UNITED STATES PATENT AND TRADEMARK OFFICE

Office Action Summary	Application No. 10/553,973	Applicant(s) GAZZA, GIANLUCA	
	Examiner DIANNE DORNBUSCH	Art Unit 3773

DETAILED ACTION

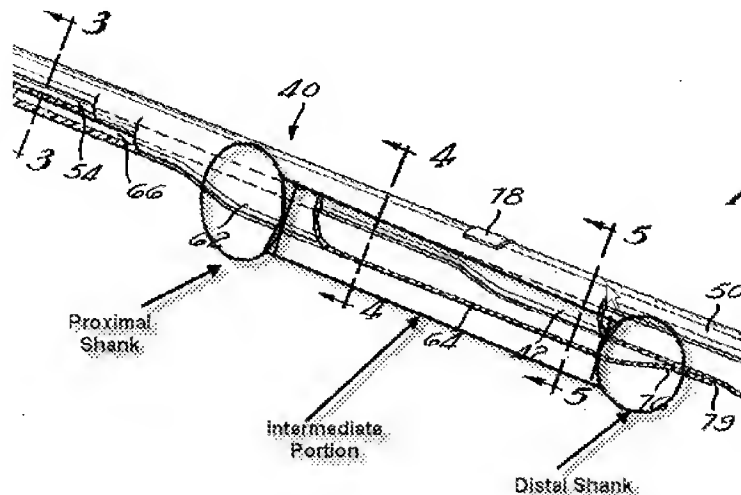
Jang discloses the following claimed limitations:

Claims 72, 101, and 105: An inflatable balloon structure (62) for catheters comprising a proximal shank (see figure below), a distal shank (see figure below), and an intermediate portion (where the cross sections 4 and 5 are taken in Fig. 2, see figure

below) between the proximal and distal shanks (see figure below); said balloon structure when the inflation chamber is expanded, has an outer surface of a circular cross-section transverse to the longitudinal extent of the balloon structure (Fig. 4-5 where it can be seen that the balloon has a circular cross-section); the balloon structure comprising a wall (64, 70, 72) which has, transverse the longitudinal extent, at any point (Fig. 1-5), an annular cross-section (Fig. 4-5), said annular cross-section being delimited externally by an outer surface (outer surface of wall 64) (Fig. 4-5) which, at least in the intermediate portion (where the cross sections 4 and 5 are taken in Fig. 2) thereof, is suitable for coming into contact with the object to be dilated (when inflated the outer surface will dilate the vessel wall), and said annular cross-section being delimited internally by an inner surface (52, 56) which delimits an inflation chamber (66), in which: at least one wall cavity (54) is provided in the wall and is formed within an annular cross-section (Fig. 4) which delimits the inflation chamber so as to be disposed between the outer surface and the inner surface the wall cavity extending, without interruptions and/or openings, longitudinally relative to the balloon structure between the proximal end and the distal end so that (fig. 3-5 and Col. 11 Lines 63-64), when the balloon structure is inflated or expanded, the outer surface of the intermediate portion has, in cross-section transverse the longitudinal extent of the balloon structure, uniform curvature around the entire annular extent of the cross-section (Fig. 4-5); the wall cavity following the balloon structure outline at least following the proximal shank and the distal shank (Fig. 1 where it can be seen that the wall cavity has the same outline as the balloon structure however they are not in face with each other).

Note that applicant does not state that the outline has to be in face with each other therefore Jang does show the outline as claimed.

Applicant argues that the Jang does not disclose a cavity wall that follows the outline of the balloon structure. The examiner disagrees, as explained in the rejection above, the wall cavity of Jang does have the same outline as the balloon structure

including the proximal and distal shank portions, however, the outline of the wall cavity of Jang is not in face with the balloon structure. Since applicant did not specify that the outline had to be in inface or out of face, the examiner interpreted it as being out of face.
